Our Ref: 80216045-CV1B-RP-001:AL  
Contact: Robert Lewis

## **MARRICKVILLE METRO S75W PROPOSED MODIFICATION RESPONSE TO SUBMISSIONS**

# APPENDIX B

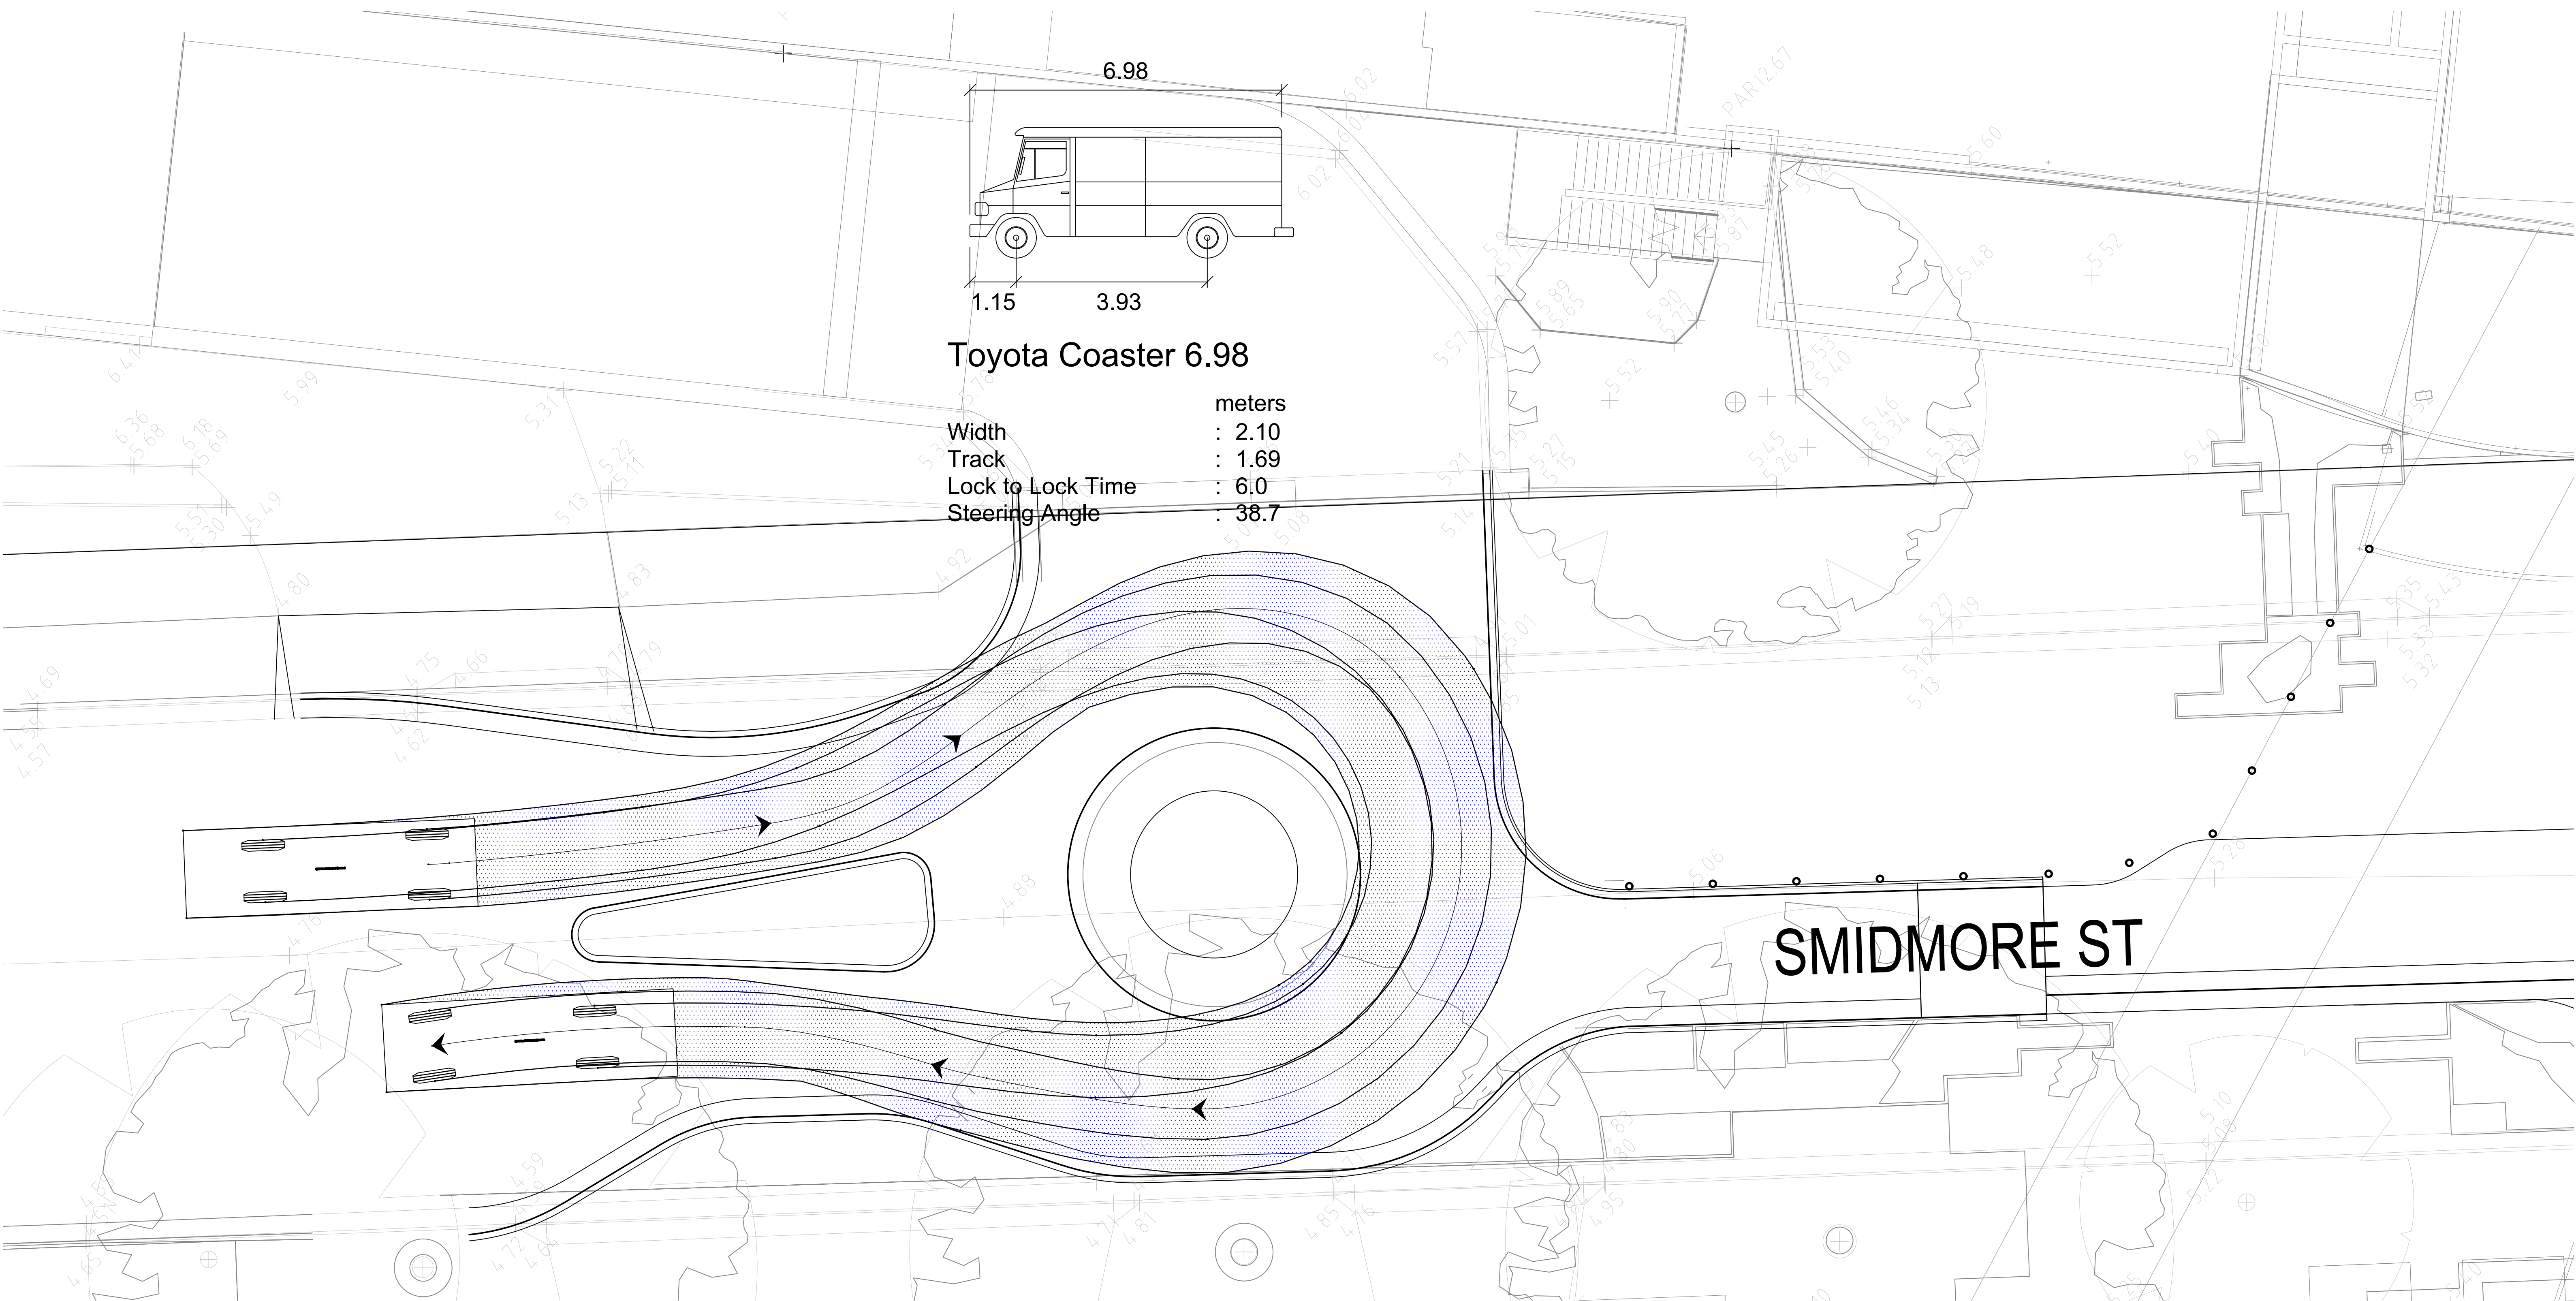
*'3. Provide additional information to demonstrate that the movement and interaction of vehicles and pedestrians in Smidmore Street can occur safely, having regard to the operation of the existing loading dock, the entry/exit ramp to the existing carpark and the roundabouts.'*

*'Swept path analysis should be prepared to demonstrate the proposed road configuration on Smidmore Street is adequate to accommodate the manoeuvring of the proposed community bus service.'*

*'The applicant should provide further information on how the existing loading dock will be operated and accessed from Smidmore Street. Swept path analysis should be prepared to demonstrate the adequacy for truck access having regards to the proposed roundabout and one-way access off Murray Street'*

*'3. Swept paths should be provided for Smidmore Street, with larger vehicles being able to manoeuvre around the roundabout without having to undertake a 3-point turn.'*

Cardno have completed turnpath analyses for various vehicles. The turnpaths demonstrate safe traffic flow around the existing entry/exit ramp and proposed roundabout by showing 99<sup>th</sup> percentile car entry, exit and U-turn movements. Refer to **Appendix A** for turnpath sketches.

The turnpaths also demonstrate that vehicles under 7m total length accessing the existing loading dock without encroaching other vehicle and pedestrian pathways. Vehicles exceeding 7m will require local pedestrian traffic control and retracting of the proposed removable bollards to access the existing Smidmore street loading dock. Refer to **Appendix A** for turnpath sketches.

Cardno have completed turnpath analyses for community bus service movements. The turnpaths demonstrate safe and adequate movement throughout proposed Smidmore Street arrangement inbound, through fare and outbound movements. Turnpath analysis also shows U-turn movements for community buses at the proposed Smidmore Street roundabout. Refer to **Appendix A** for turnpath sketches.

The turnpaths analysis demonstrates safe large vehicles movements around the proposed roundabout by showing the community bus accomplishing U-turns. Refer to **Appendix A** for turnpath sketches.

DELIVERY VEHICLE TO LOADING DOCK BAYS PERMITTED  
ONLY WHEN REMOVABLE BOLLARDS ARE RETRACTED  
AND PEDESTRIAN TRAFFIC CONTROL IS PRESENT.

# APPENDIX D

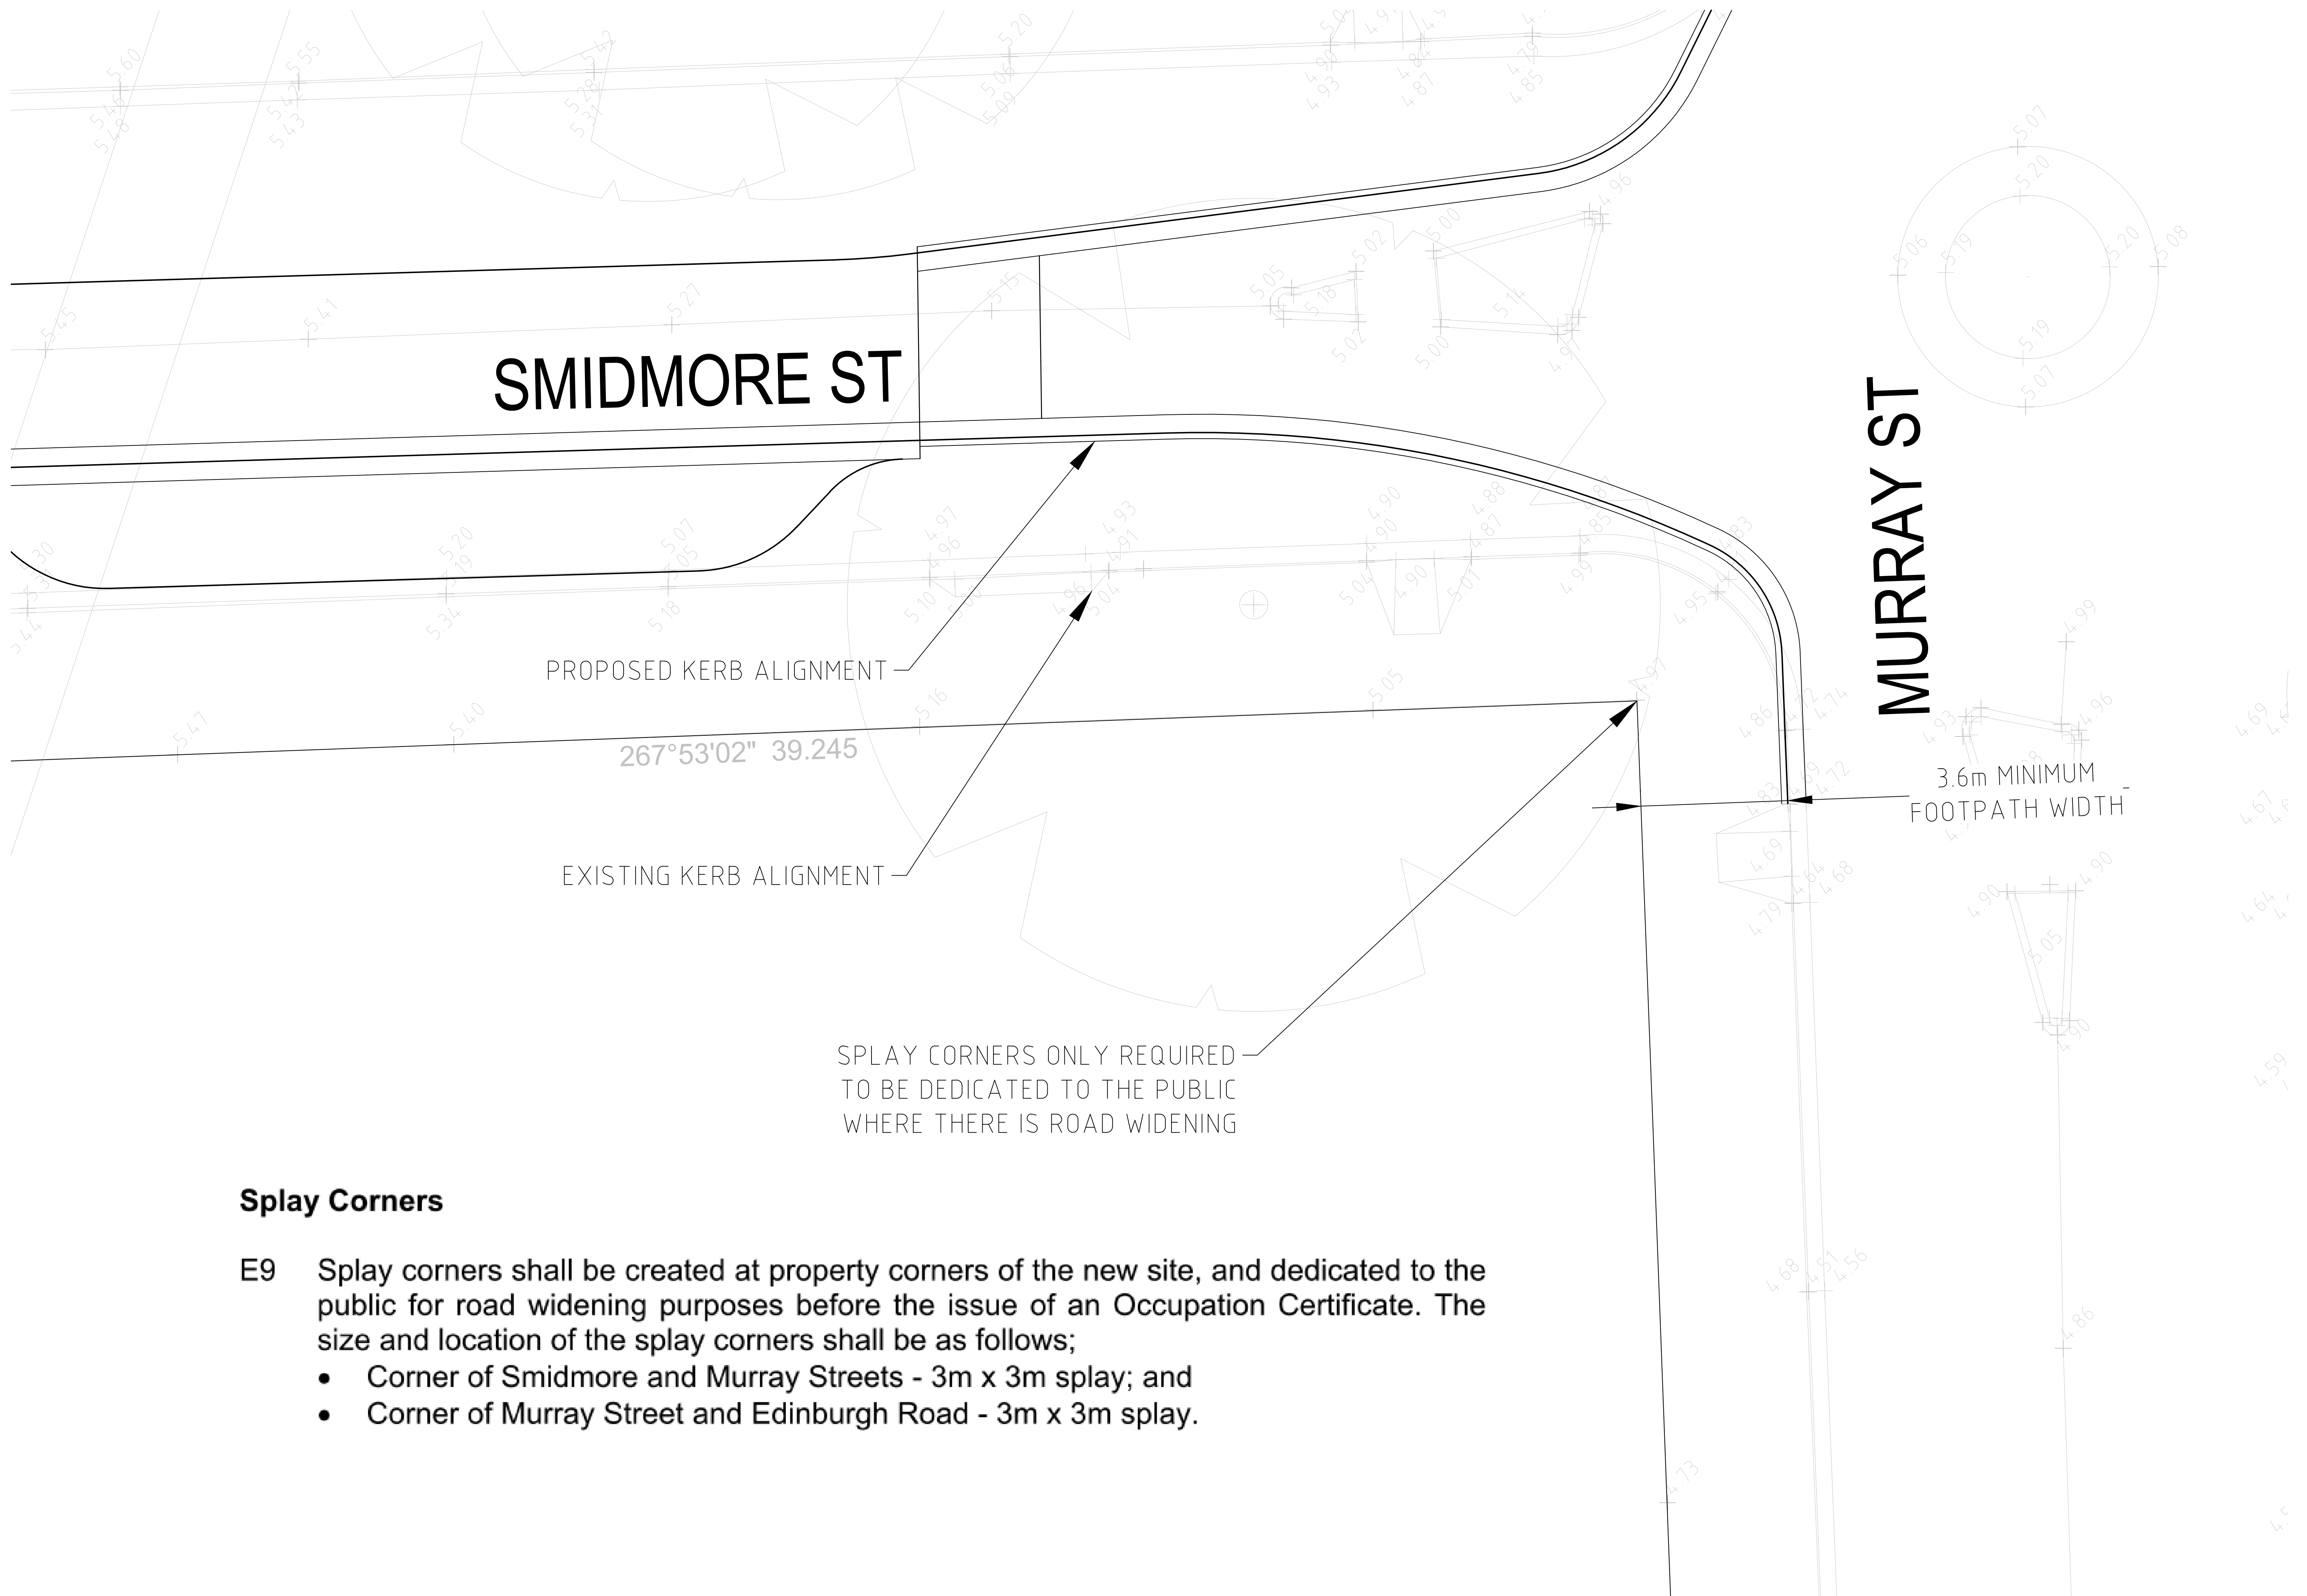
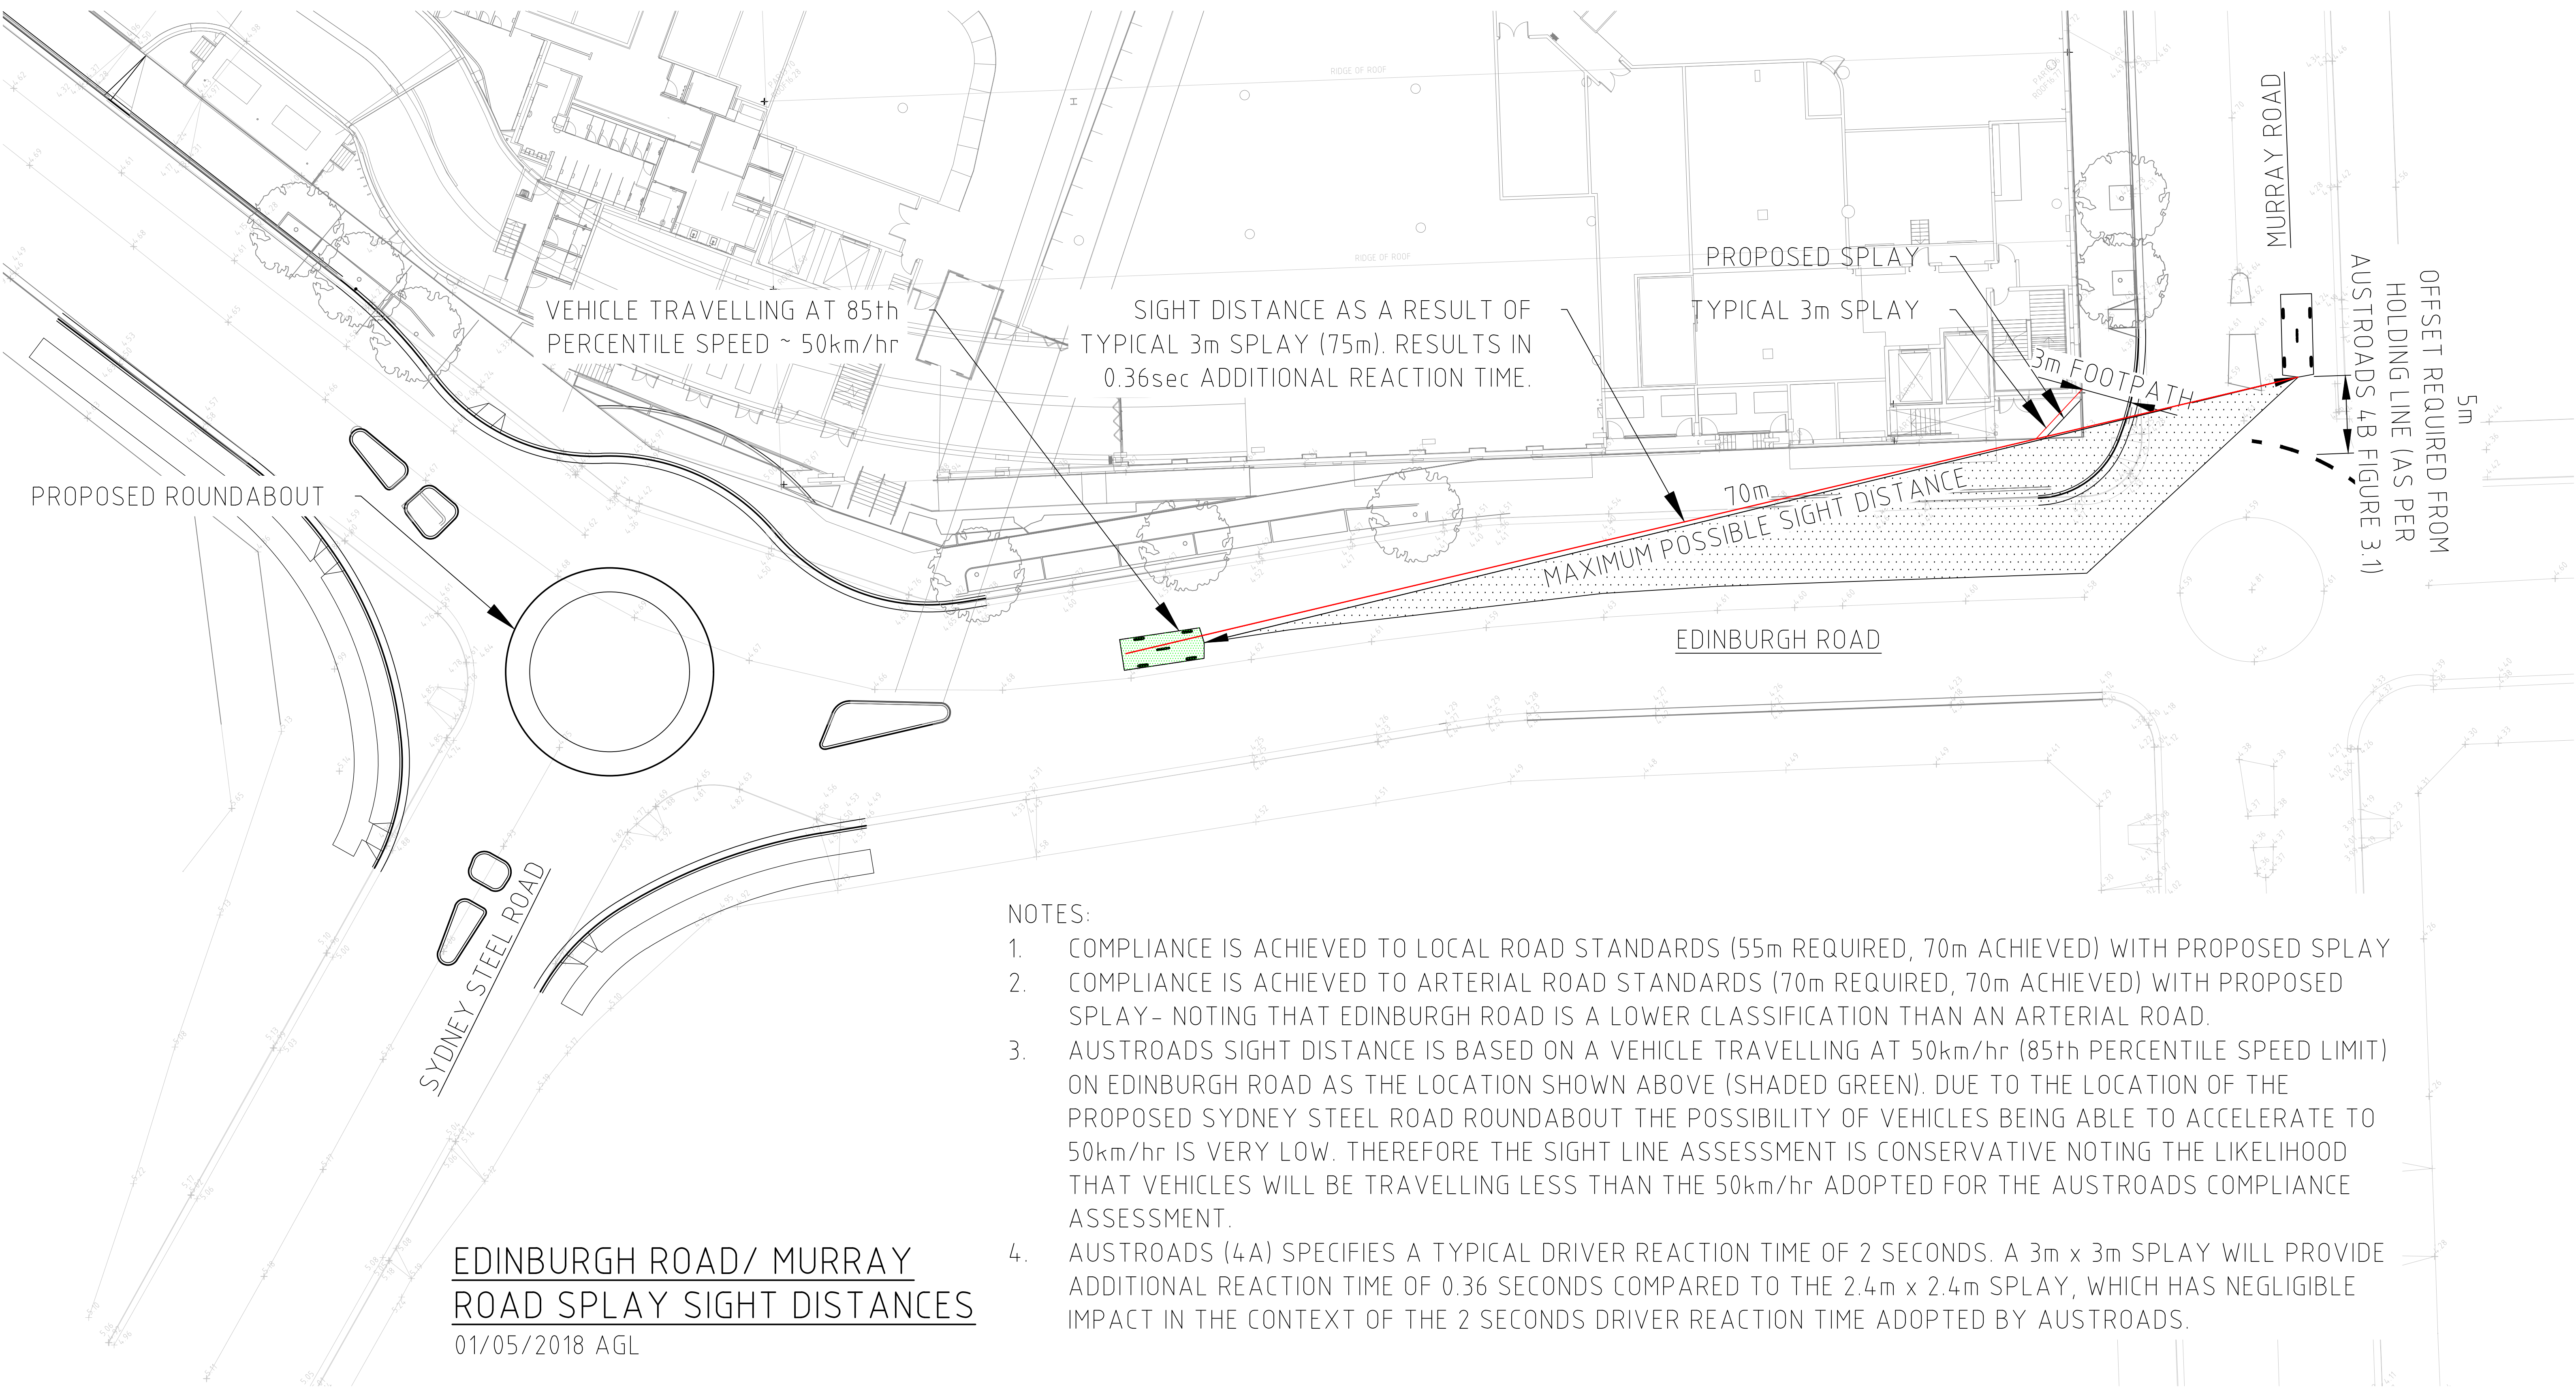
*'3m x 3m splay corners are required on junctions of Smidmore/ Murray, Edinburgh/ Murray, Edinburgh/ Smidmore'*

- E9 Splay corners shall be created at property corners of the new site, and dedicated to the public for road widening purposes before the issue of an Occupation Certificate. The size and location of the splay corners shall be as follows;
- Corner of Smidmore and Murray Streets - 3m x 3m splay; and
  - Corner of Murray Street and Edinburgh Road - 3m x 3m splay.

The proposed development works do not widen roads near the Smidmore/Murray and Edinburgh/ Smidmore intersections. Splays are therefore not required at because the proposed works do not negatively impact the existing intersection sightlines or decrease footpath areas. Refer to **Appendix D**.
